## Response to supplementary questions

On Thursday the 21<sup>st</sup> April 2016 eleven questions were received from the STFC in preparation for the MICE-UK cost-to-completion review. Answers to each of these questions are given below.

Figure 1: Transmission (left) and emittance reduction (right) as a function of input emittance for 200 MeV/c beams. The error bars correspond to  $\sim 100k$  muons passing through the experiment.

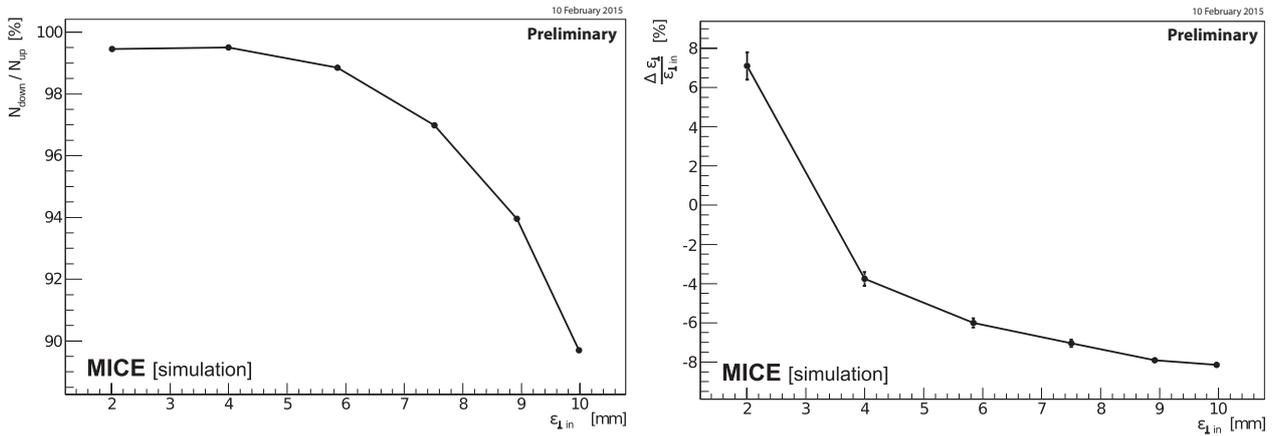
**2. If further funds were invested into the project, how confident is the Collaboration that cooling will be demonstrated?**

hardware of the cooling demonstration will be that used in the Monte Carlo analysis of the performance of the experiment [3–7]. The cooling lattice has been extensively modelled and shown to have performance that significantly exceeds the precision with which the emittance-change measurement can be made. An example is shown in figure 1 where the transverse emittance and transmission of the cell is shown as a function of input emittance for a 200 MeV/c beam.

Figure 2: Emittance reduction with (left) two high-power RF amplifier (baseline condition) and (right) with only one RF amplifier available.

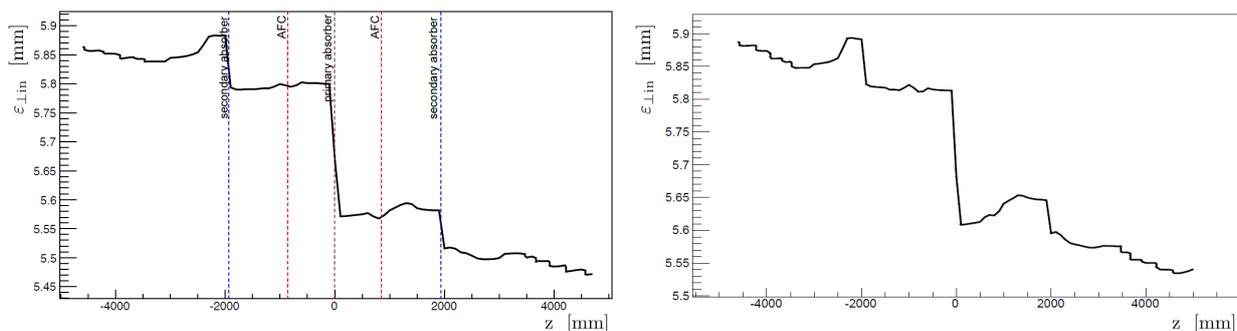
(a) **there is only one RF system;**

The collaboration has performed a first study of the effect of using only one RF-amplifier system to power both cavities. To first approximation this would reduce the available RF voltage by a factor  $1/\sqrt{2}$ . The mean energy recovered will be reduced from 6.6 MeV to 4.7 MeV, compared to the mean energy loss in the primary absorber of around 11 MeV. The RMS transverse emittance reduction (cooling) is reduced from 5.8% in the two-amplifier configuration to 4.8%. The resulting emittance reduction is shown as a function of position along the axis of the experiment in figure 2.

Figure 3: Top: schematic diagram of the cooling-demonstration configuration. Centre and bottom: schematics of the descope options discussed in the text that may be considered in the event that the downstream solenoid is not available.

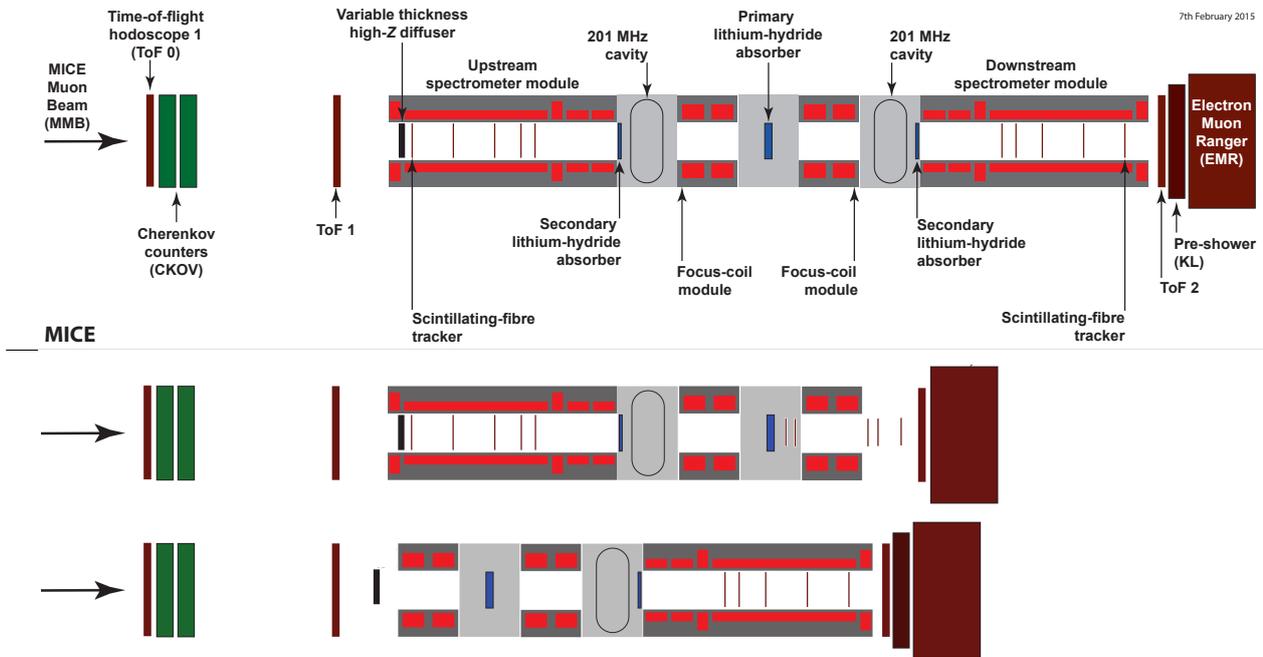
(c) **having only one RF system and one magnet?**

Two options have been identified in the event that a second spectrometer solenoid is not available beyond Step IV (see figure 3):

- An arrangement has been envisaged that would use the excellent reconstruction capabilities of the EMR detector to measure particle range and hence absolute momentum, together with tracker stations around the downstream focus coil that would measure particle position and angle. The aperture of the tracker is narrower than that of the focus-coil module, while the beam radius can be relatively large in this region; i.e. it may be that the beam envelope is larger than the acceptance of the tracker stations. Such an arrangement may prevent installation of the downstream RF cavity due to geometrical constraints and concerns of radiation damage to the downstream detectors. The overall resolution achieved in the downstream region would need to be studied; and

- In extremis, it may be possible to make some measurements using only the downstream tracker. The spectrometer solenoid that is presently upstream of the cooling cell would be placed downstream of the cooling cell. The emittance-reduction measurement would be achieved by comparing the beam emittance measured in the tracker with and without an absorber. Such an arrangement would require stability of the MICE Muon Beam on a timescale sufficient to permit emptying and filling of the absorber to enable the difference measurement. As sampling of the
